Request for Rezoning 308 Cones Road / 90 Dixons Road

Transportation Assessment

To: Waimakariri District Council
From: Antoni Facey
CC: Andy Carr
Date: 18 September 2023
Re: **Plan Change-308 Cones Road and 90 Dixons Road**

project Submission to Waimakariri District Plan Review
to Antoni Facey, Avanzar
from Andy Carr, Carriageway Consulting Ltd
date 10 February 2024
subject Response to Requested Sensitivity Test

Figure 1: Revised Weekday Morning and Evening Peak Hour Traffic Generation at Full Site Development

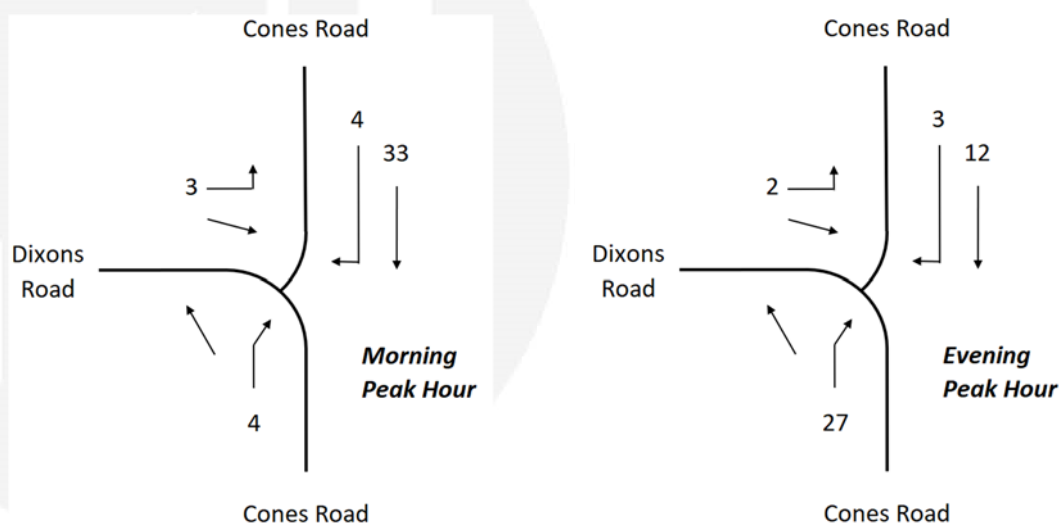
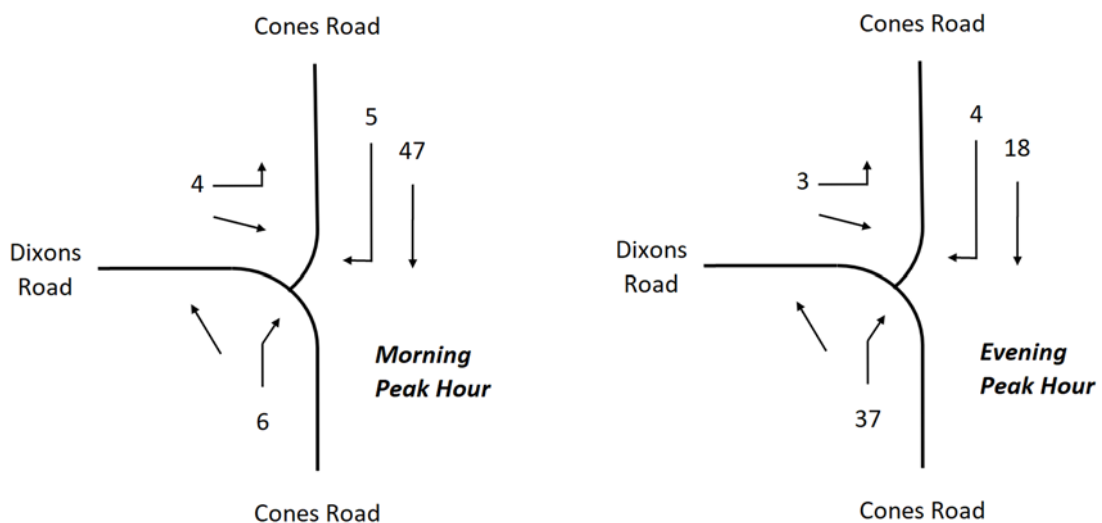
The Proposed District Plan provides traffic generation rates in TRAN-APP6 based on Research Report 453. For a rural residential unit the PDP recommends that a daily rate of 10.1 vpd/unit should be used and 1.4 vph/unit in the peak hour.

The Transportation adopted a figure of 1 vehicle movement per lot in the peak hours. The requested sensitivity test therefore represents a 40% increase in this. Accordingly, we have increased the traffic generation shown on Figure 7 of the Transportation Assessment by 40%, and the revised volumes are shown below.

In summary there are few differences between the sensitivity test carried out previously, and the revised testing using the increased trip rate. The greatest change arises in the evening peak hour for the right-turn movement from Cones Road (north), but even this is a change of less than one second compared to the situation with no site development, and with no consequential change in queue length or level of service.

The analysis continues to show that the traffic associated with the requested rezoning can be accommodated on the roading network without capacity or efficiency issues arising.
